**DALLAS FORT WORTH
INTERNATIONAL AIRPORT**

ADDENDUM NO. 01

RENTAL CAR CENTER SERVICE SITE HAIL CANOPIES

CONTRACT NO. 9500711

**TYP. 2 COLUMN
 CANTILEVERED
 CANOPY PLAN
 & ELEVATIONS**

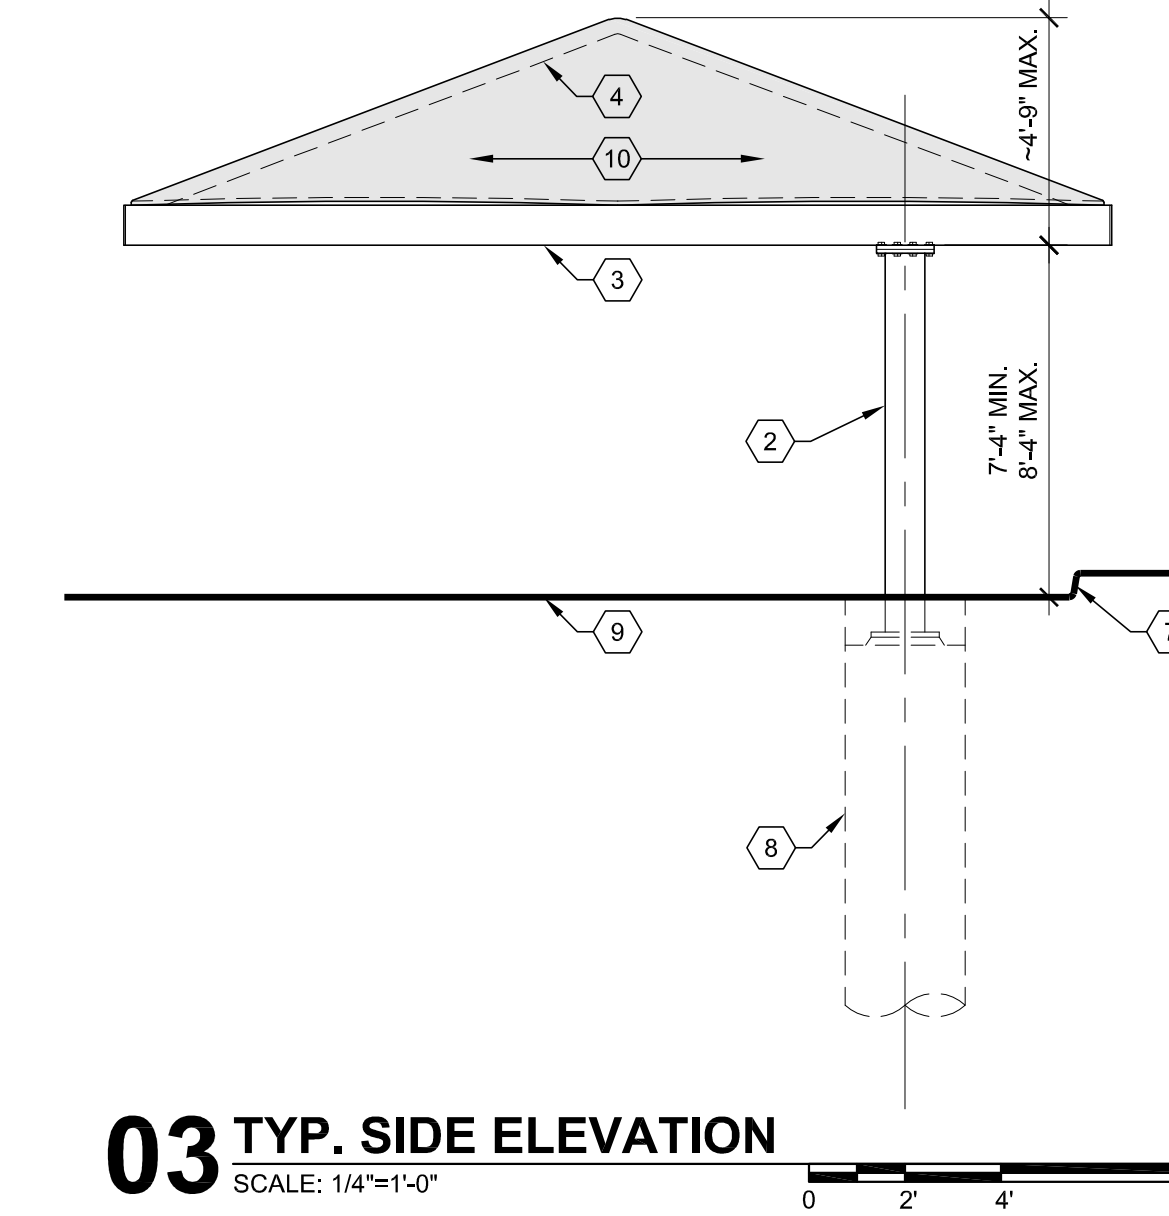
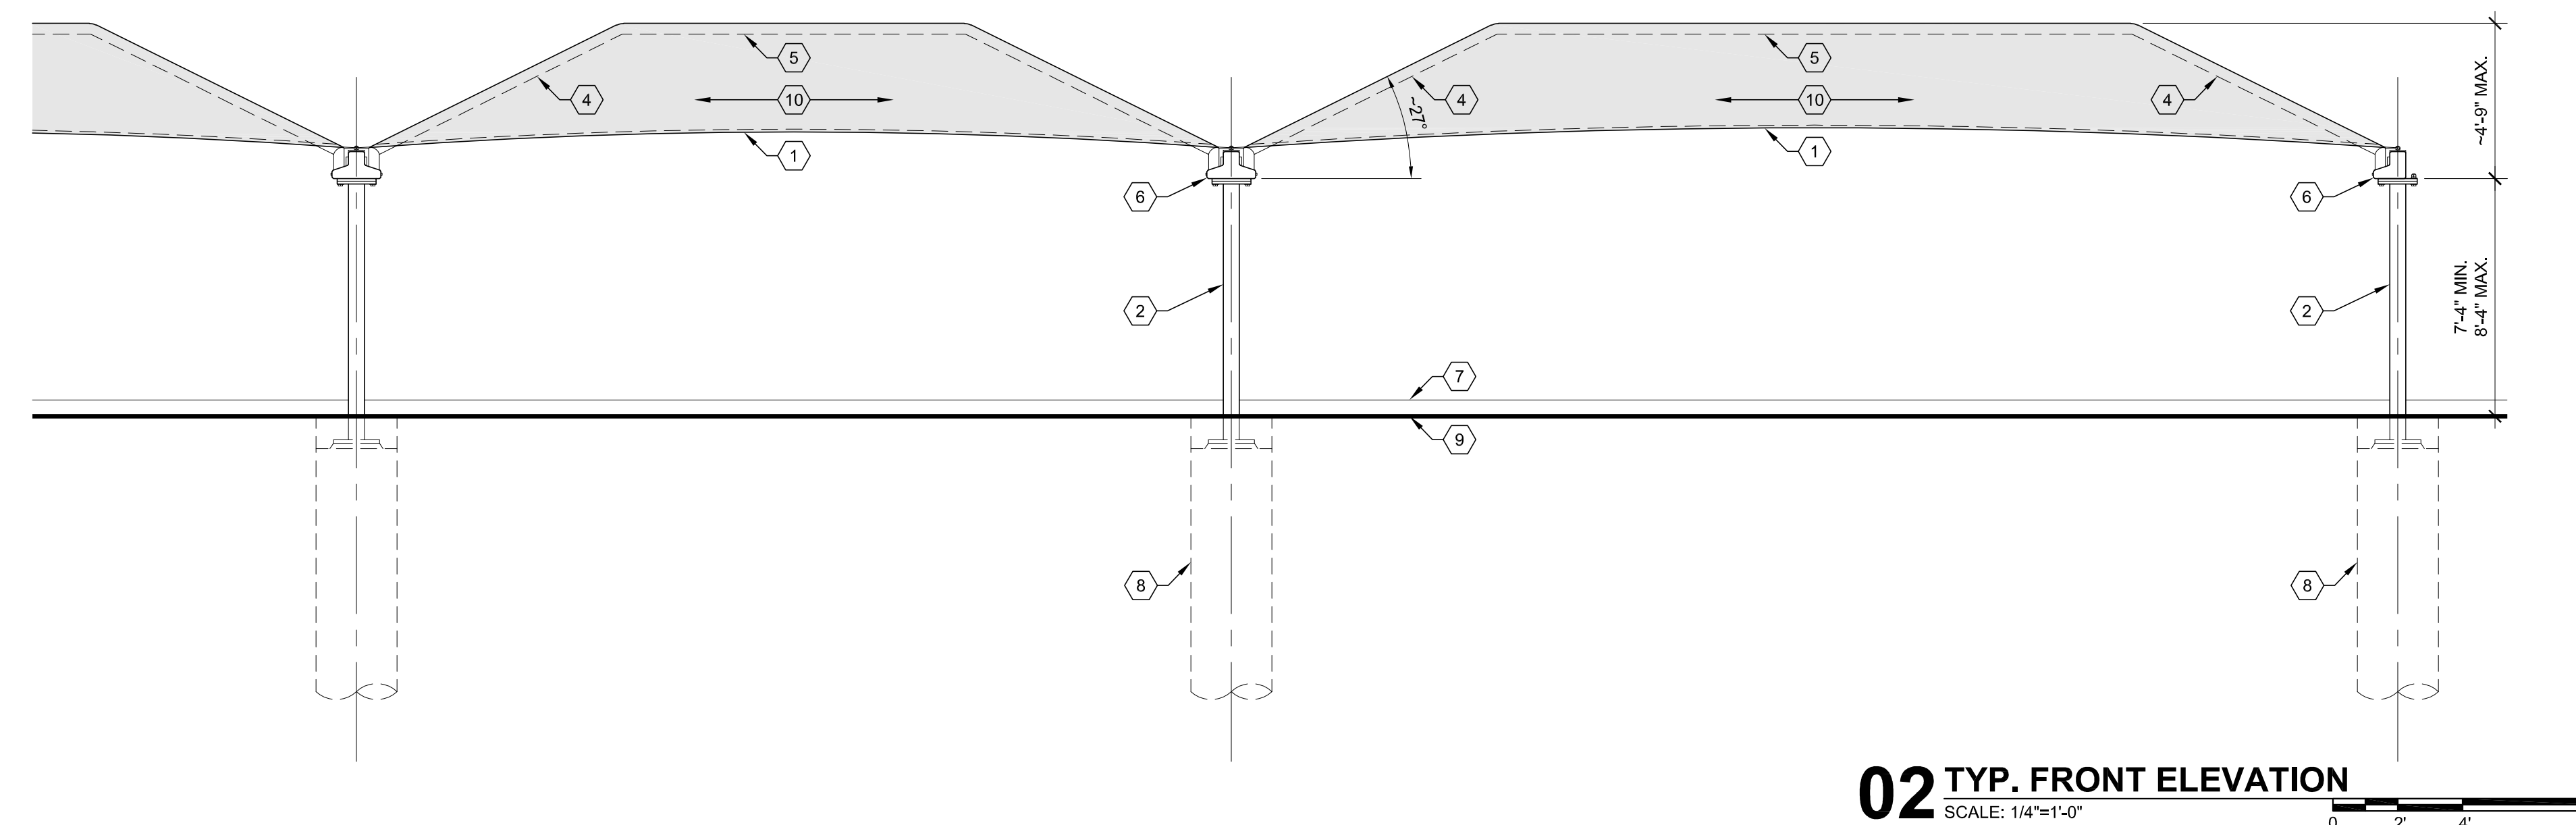
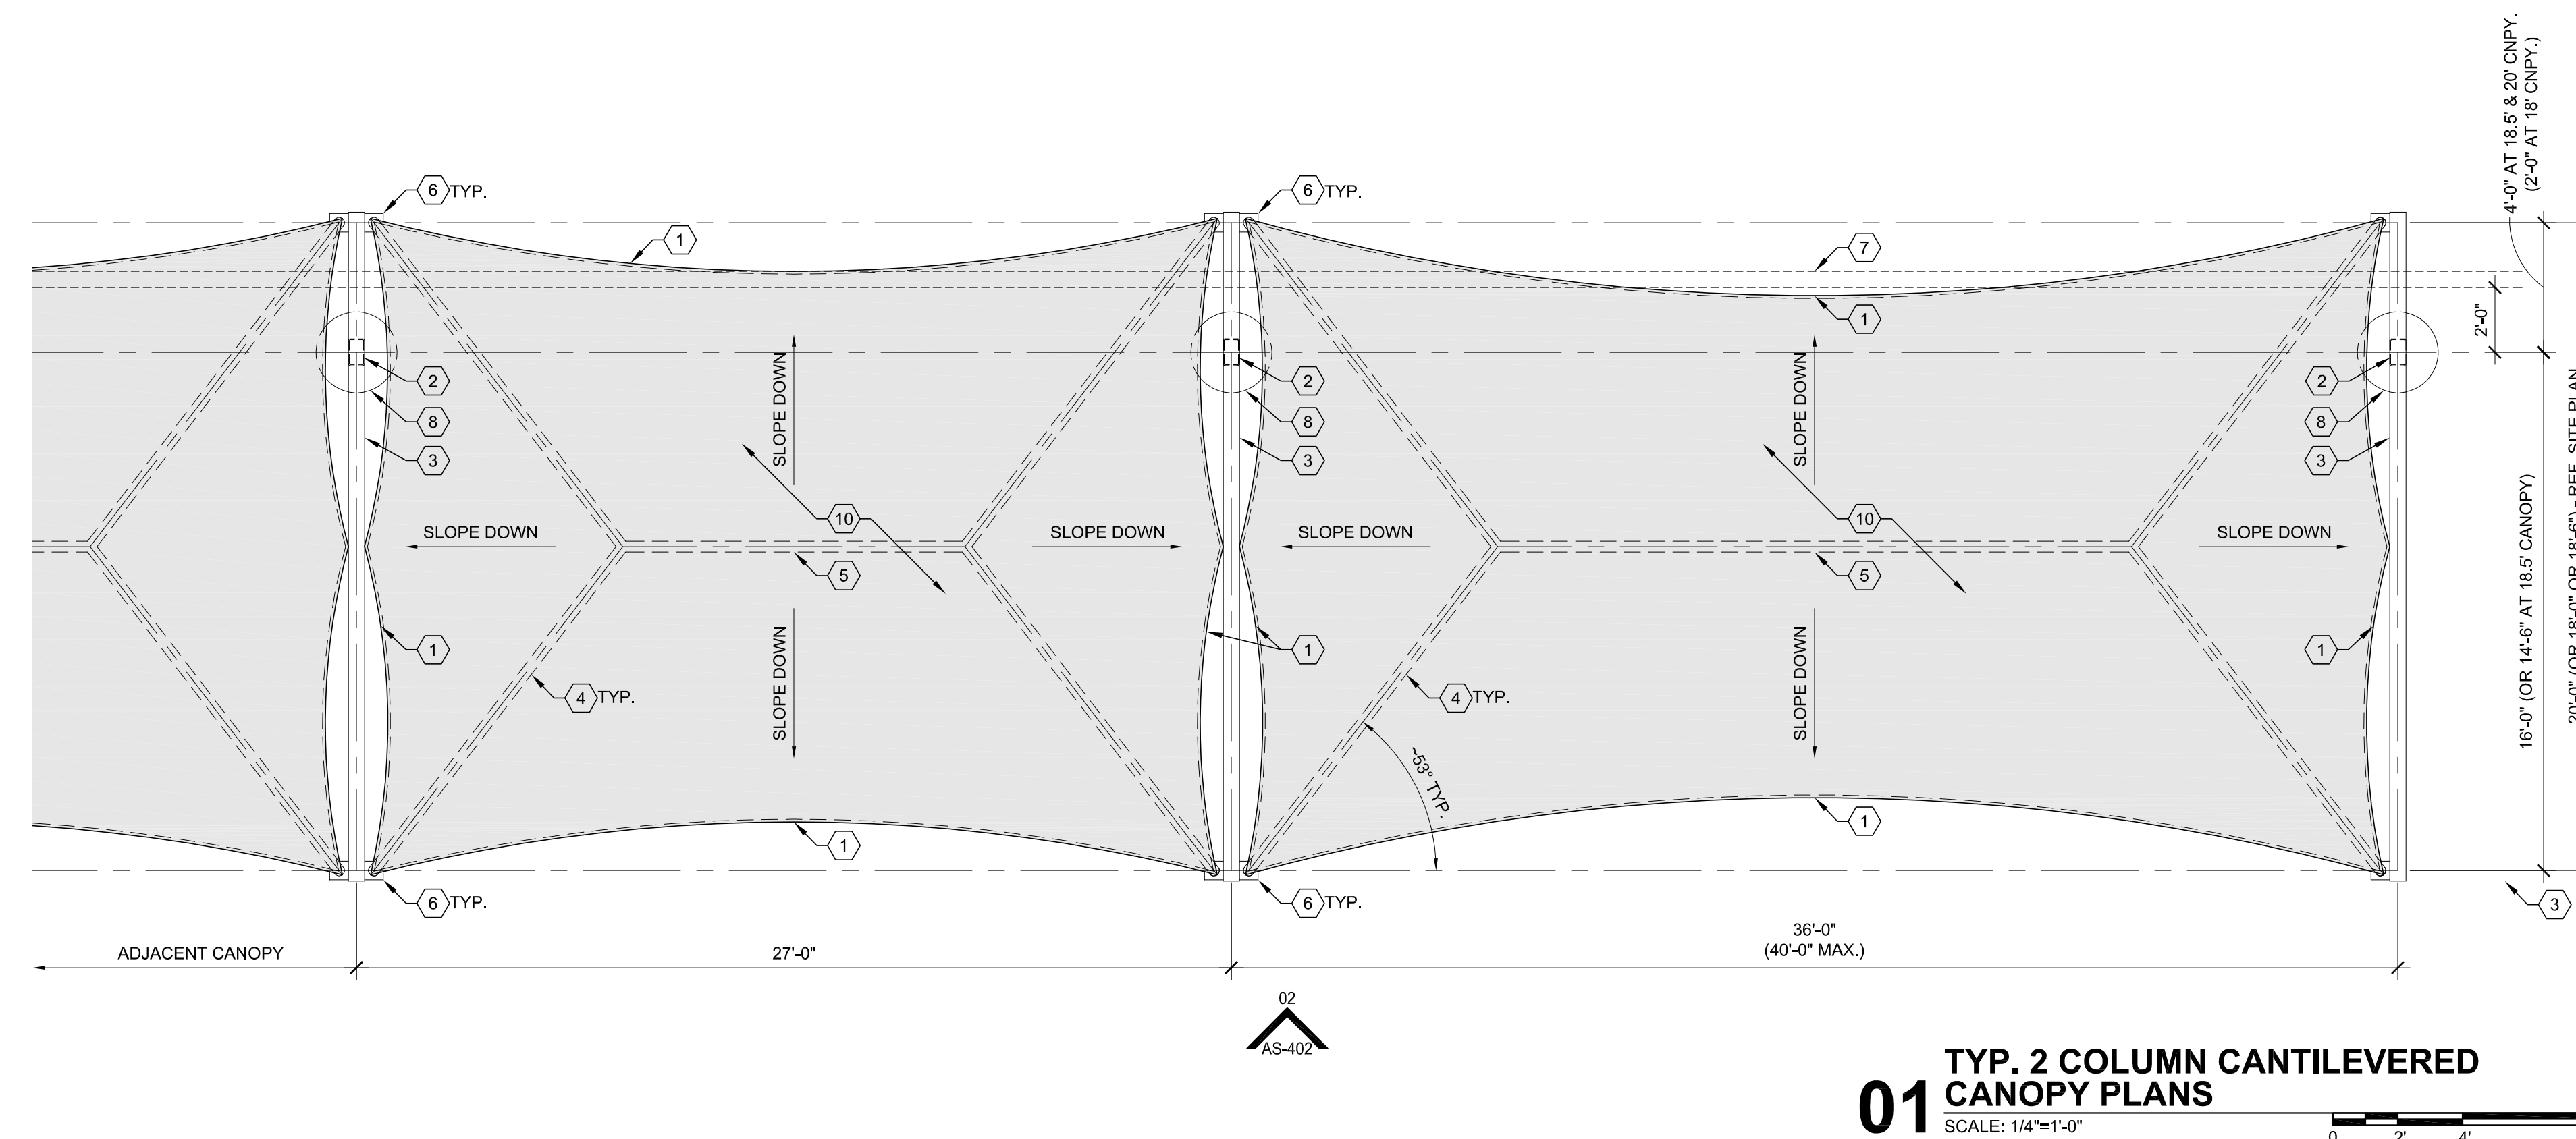
1. COVER SHEET, INDEX OF DRAWINGS, GEN. REQMTS. NOTES, MAPS:
 - a. Added note number 27 to the GENERAL REQUIREMENTS NOTES.
2. AS-401 TYP. 4 COLUMN CANOPY PLAN & ELEVATIONS:
 - a. Added note number 3 to the GENERAL NOTES.
3. AS-402 TYP. 2 COLUMN CANTILEVERED CANOPY PLANS & ELEVATIONS
 - a. Added Note number 3 to the GENERAL NOTES.

- CONTRACTOR TO REFER TO SPECIFICATION SECTION 13 31 33 PRE-ENGINEERED HAIL PROTECTION/SHADE STRUCTURES AND APPENDIX A FOR GEOTECHNICAL REPORT DATED MARCH 3, 2020 INCLUDING ADDENDUM LETTER DATED APRIL 29, 2020 FOR DATA INFORMATION TO BE UTILIZED IN DEVELOPING THE FOUNDATION DESIGN OF CANOPY STRUCTURES. AT THE CONTRACTORS OPTION, THEY MAY UTILIZE EITHER DRILLED PIER FOOTINGS, SPREAD FOOTINGS, OR A COMBINATION OF THE TWO TYPES OF FOOTINGS AS APPROPRIATE FOR THE SYSTEMS AND CONDITIONS. CONTRACTOR IS RESPONSIBLE FOR ANY/COSTS ASSOCIATED WITH THEIR CHOICE OF FOUNDATION SYSTEM UTILIZED INCLUDING ANY MODIFICATIONS RELATED TO THE DESIGN, RE-ROUTE/EXTENSION OF UTILITIES, RE-GRADING, PAVEMENT REPAIR OF EXCAVATED AREAS, ETC.
